Twin Lakes Aquifer Recharge Project

Final Conceptual Design Report

June 30, 2003

Figure 2. Site Map for Proposed Well Location.

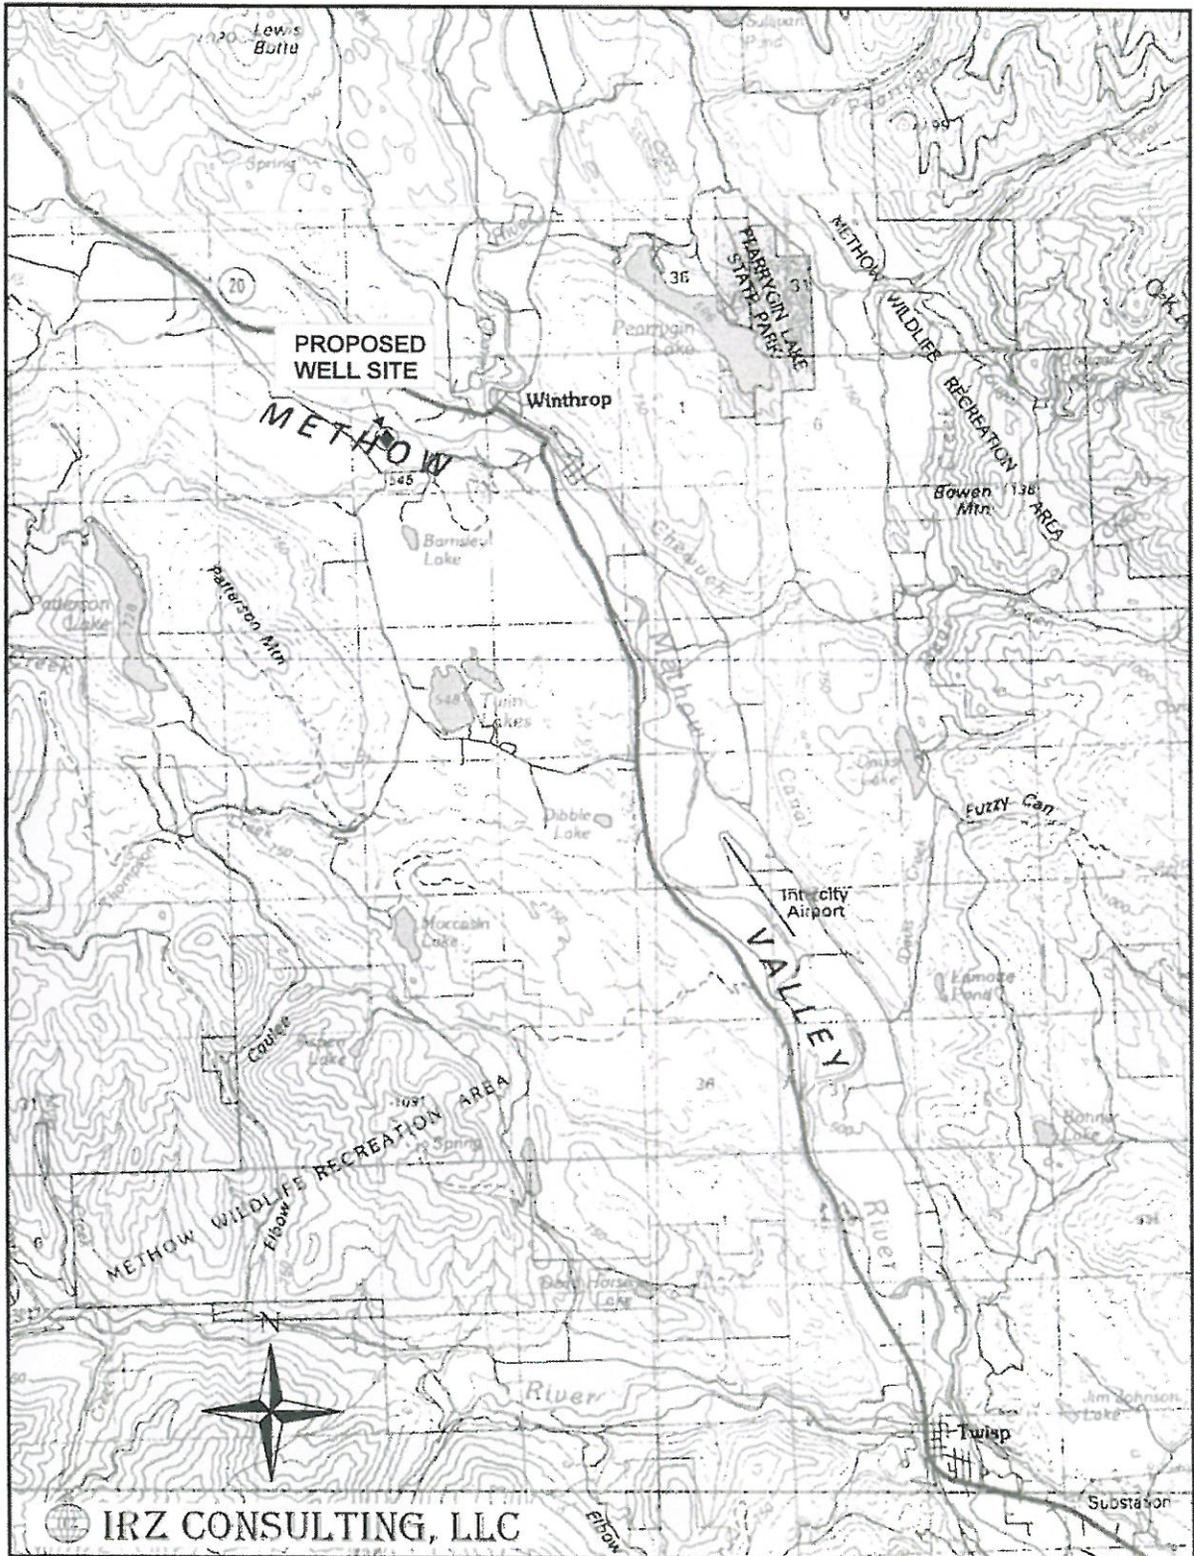
- Comment: Assuming an interception well system would be installed very close to the mainstem Methow River, it should be noted that this reach of river has been determined to have hyporehic characteristics important for spawning and food sources for fish. It may not be in the Public interest to allow a ground water installation that may have potential to degrade or negatively affect this area of the river.

- Comment: The State Fish Hatchery has four production wells and one domestic well. Personal communications with hatchery staff indicate that the production wells have a chronic sanding problem requiring regular maintenance. This suggests the possibility of improperly sized screens, or, the possibility that the rate of pumping is too high for the formation. Geologic studies conducted at the site also show an irregular aquifer base, thinning toward the river and thickening away from the river.

- Comment: Prior to any drilling, consideration should be given to the potential effects of this project on existing right holders in the area during testing and during the life of the proposed project. Tests should be designed to not only resolve aquifer parameters, but also for demonstrating the nature of effects on neighboring well users. Further, a minimum 72 hour test may be more appropriate than the proposed 24 hr test and should include neighboring wells as observation wells if possible.

- Comment: Assuming this project is seeking a right to withdraw water during the time of the spring freshet, it is imperative to examine existing rights in the area. For instance, the State Fish Hatchery’s period of greatest water use occurs between October 1st and April 15th with use peaking in march and april. Likewise, the Federal Fish Hatchery’s period of greatest water use is similar and occurs at this same time. It is uncertain if the proposed additional withdrawal at this location could occur without creating impairment issues.
